RE: 7630 Gambrills Cove Rd., Curtis Bay, MD 21226 / B02423873

Letter of Explanation

**SITE: BWI40050**  
 7630 Gambrells Cove Road  
 Curtis Bay, MD 21226

sign 1 - qty (1)

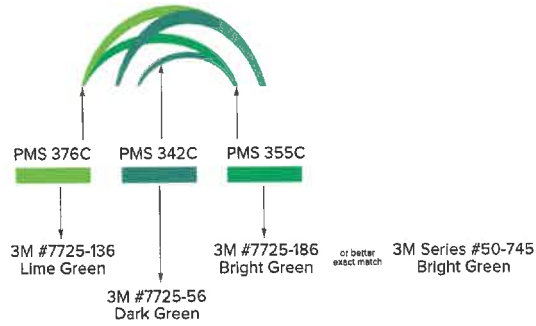
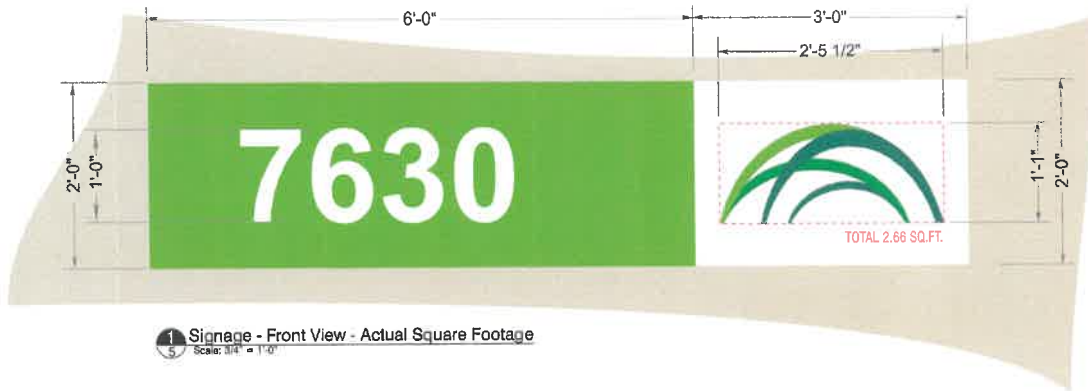
In accordance with Article 18-3-303 (c) Location. A sign shall be located within the lot lines of the use to which it refers.

In accordance with Article 18-3-308 (b) Identification signs. A business complex may have:

(1) Identification signs for the name of the business complex.

(2) Identification signs for the name of a tenant.

The logo is considered "off-site advertising". The logo cannot be permitted, unless the logo is for the actual tenant in the building or property owner.
